## **Access Compliance Report Public Rights-of-Way** (Curb Ramps)

Intersection ID: 13635 Main Street: E BLAND ST Cross Street: SOUTH\_BV Location: ADA ID: 1B49A6667CF5 Ramp Type: PerpDiag Initial Pass/Fail: Fail **Overall Compliance: No Severity Score:** 12.5

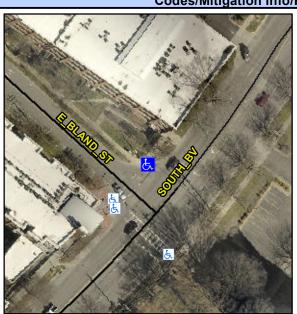
Field Measurements/Component Compliance					
Compliance Description D		Data	Comp	liance Description	Data
N/A	Ramp Length (in)	89.0	No	Ramp Slope (%)	11.6
Yes	Ramp Width (in)	63.0	Yes	Ramp XSlope (%)	0.1
N/A	Flare Type LT	N/A	N/A	Flare Type RT	N/A
N/A	Flare Slope LT (%)	N/A	N/A	Flare Slope RT (%)	N/A
N/A	Flare Traversable LT?	N/A	N/A	Flare Traversable RT?	N/A
N/A	Landing Length (in)	N/A	N/A	DWS Provided?	N/A
N/A	Landing Width (in)	N/A	N/A	DWS Contrast?	N/A
N/A	Landing Slope (%)	N/A	N/A	DWS Length (in)	N/A
N/A	Landing X Slope (%)	N/A	N/A	DWS Full Width?	N/A
N/A	Landing Curb? (Y/N)	N/A	N/A	DWS Offset (in)	N/A
N/A	Shared Landing?	N/A			
N/A	Gutter Ponding?	N/A	N/A	Gutter Slope (%)	N/A
N/A	Gutter Lip Ht (in)	N/A	N/A	Gutter X Slope (%)	N/A
N/A	Painted X Walk1?	Yes	N/A	Painted X Walk2?	No
	X Walk 1 Direction	To SW		X Walk 2 Direction	To SE
N/A	X Walk 1 Width (in)	108.0	N/A	X Walk 2 Width (in)	N/A
	X Walk 1 Slope (%)	0.7		X Walk 2 Slope (%)	7.8

X Walk 1 X Slope (%)	1.4		X Walk 2 X Slope (%)	1.2
N/A	Ramp inside XWalk1?	Yes	N/A	Ramp inside XWalk2?	N/A
	Road Slope (%)	0.1	N/A	Clear Space?	N/A
	Road X Slope (%)	0.1	N/A	Clear Space to XWalk (in)	N/A
N/A	Any Obstructions?	N/A	N/A	Storm Grate/Utility Hazard?	N/A
	Obstruction Type			Storm Grate/Utility Type	
		N/A			N/A
			Yes	Surface Condition? (G/P)	Good

Possible Solutions: Remove & Replace Curb Ramp With **Two New Directional Ramps or** Equivalent. Surveyor Notes: N/A PROW/ADA: Not Found, R304.2.2
